Request for Proposal Number: 13-23A1

Addendum 1

Date: February 27, 2013

The following drawings replace the illustrated examples of signage and wayfinding components described in the RFP. These drawings are meant to provide additional information clarifying the informational, material, and fabrication requirements for the following components:

Wayfinding "Totem" - Rectilinear Design

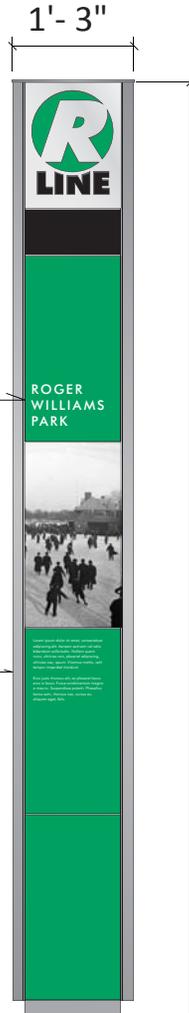
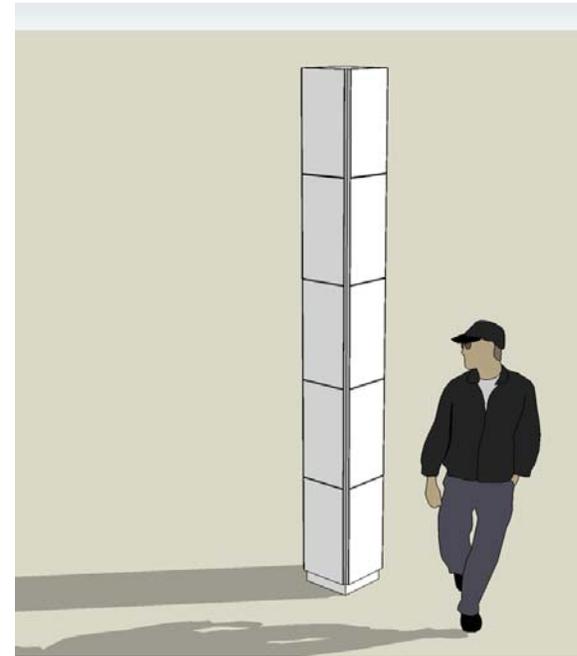
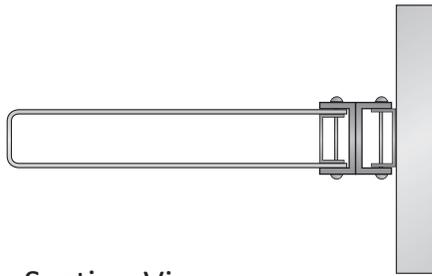
Four sided wayfinding and information kiosk with aluminum angle frame and tube structure, removable information graphic panels, an internally illuminated R-Line logo, and an LED real-time information display.

Enhanced Transit Sign - Rectilinear Design

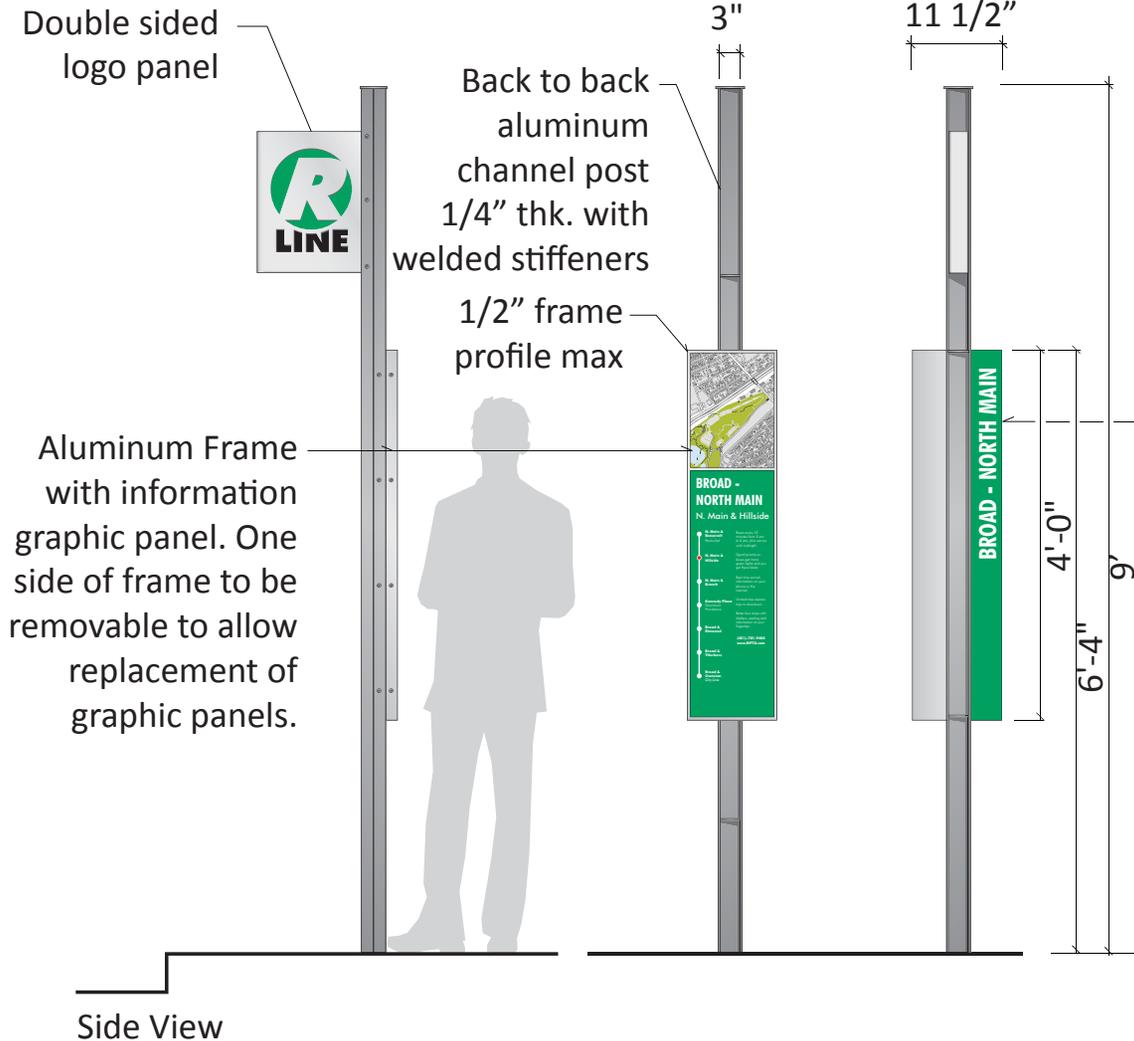
Back to back 3" x 1.5" channel post with welded stiffeners, break formed, double sided, aluminum logo panel, and information panel with aluminum frame and polycarbonate non-glare face, and second surface graphics.

Logo Panel: Logo knocked out of aluminum panel, and backed with painted aluminum panel.
 Information and Map: Digital prints on second surface of non-glare acrylic panel.
 Back side route ID sign: Painted background with masked and sprayed lettering.

Shelter Signs and Graphics - Rectilinear Design

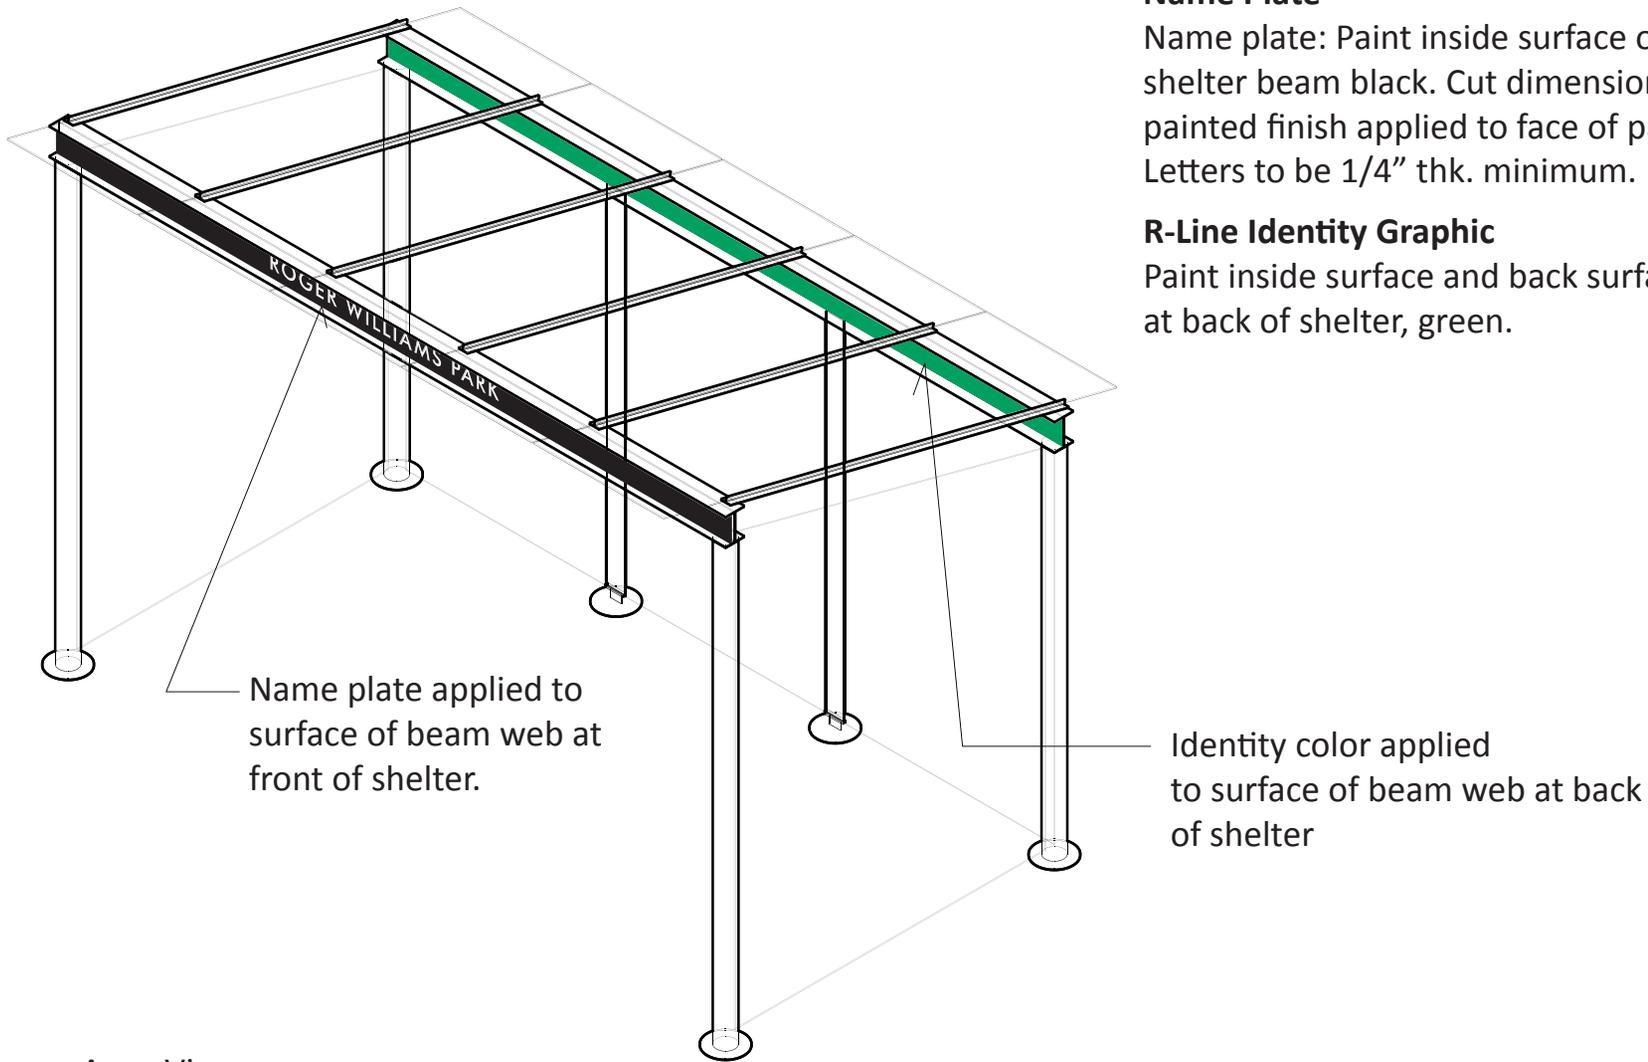
Signs and graphics for the shelter consist of a name plate and R-Line identity graphics.

Name plate: Paint inside surface of web of front shelter beam black. Cut dimensional letters with painted finish applied to face of painted web. Letters to be 1/4" thk. minimum.

Paint inside surface and back surface of beam web at back of shelter, green.

Wayfinding "Totem" - Curved Design

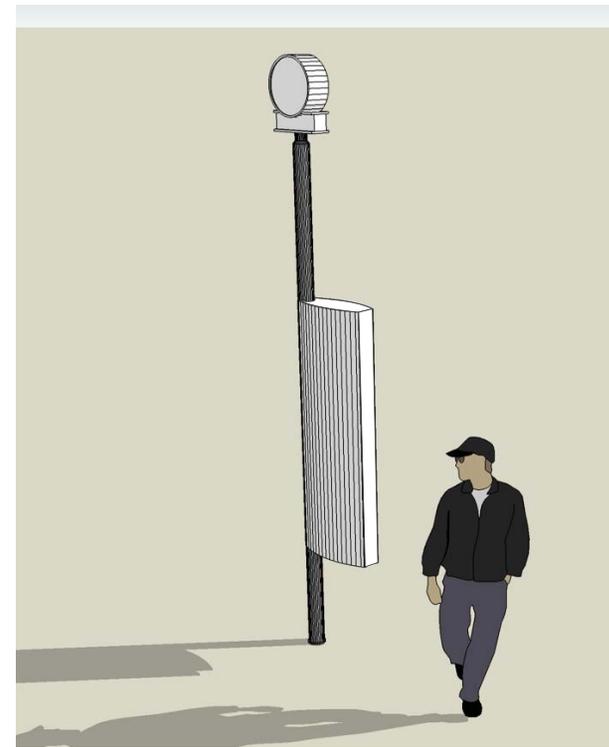
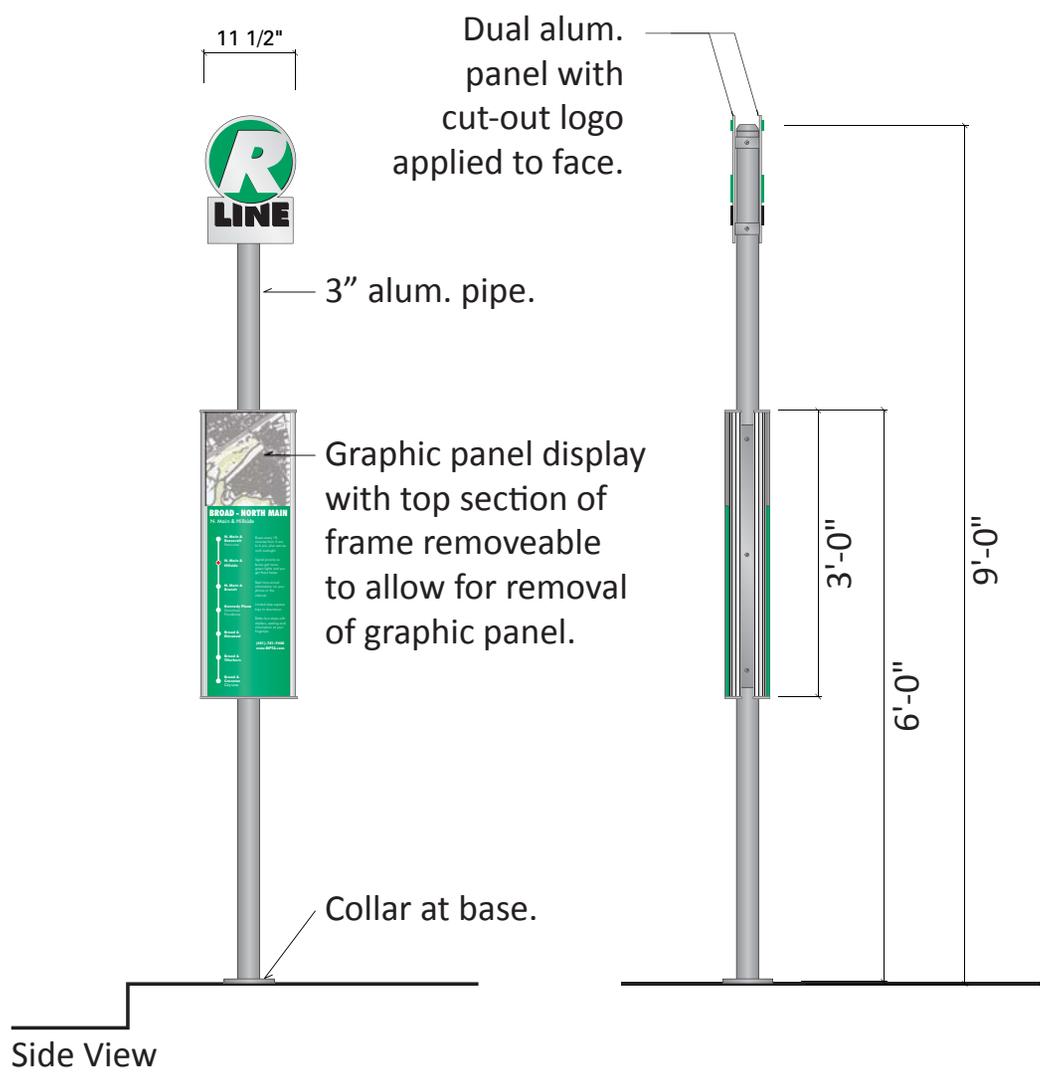
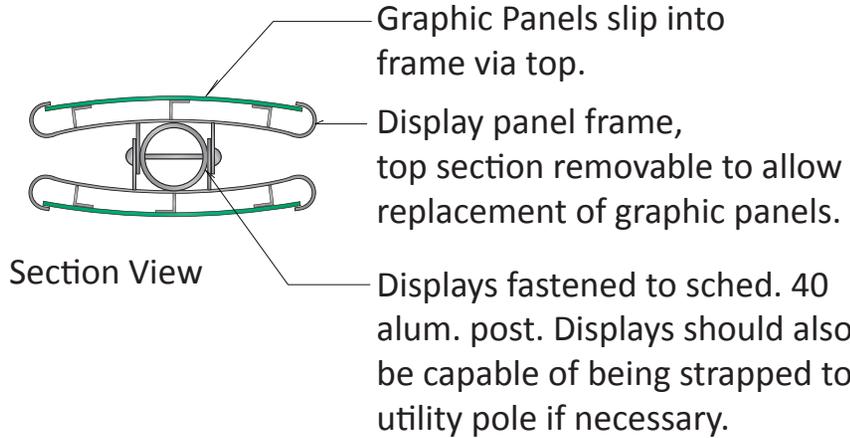
Two sided post and panel wayfinding and information kiosk with LED real-time information display, internally illuminated R-Line logo, and removable information graphic panels.

Information Graphic panels: Digital prints on second surface of 1/8" non-glare polycarbonate.
Real-time Information Display: Amber LED

Shelter Signs and Graphics - Curved Design

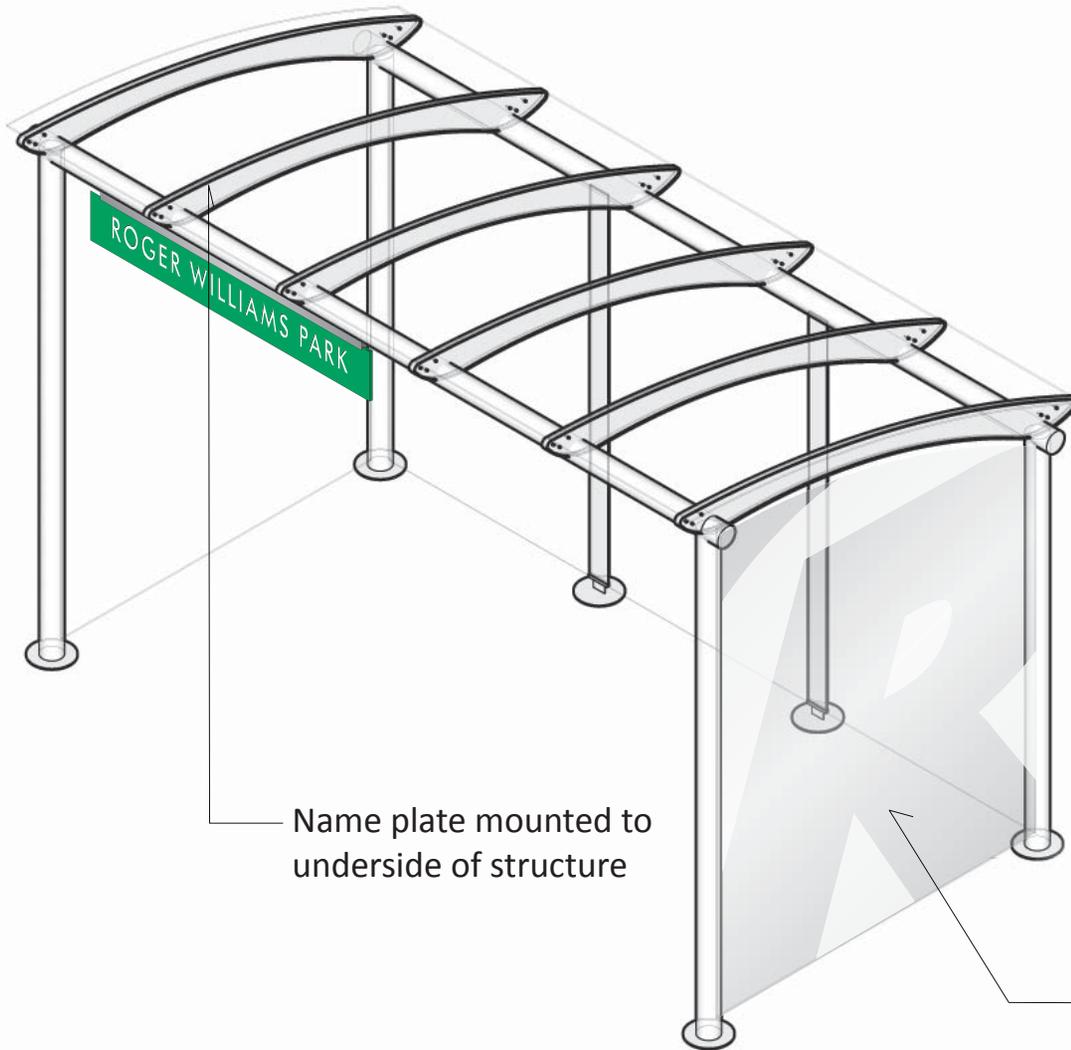
Name plate: 1/8" alum. with silver painted finish and 1/4" acrylic panel with green painted finish applied to face. Lettering knocked out of acrylic panel. Attached to structure with full length aluminum bracket painted silver.

Frosted R-Line logo on interlayer of glass side panel, leading side only. Graphic to be interlayer only. Surface applied graphics will not be accepted.
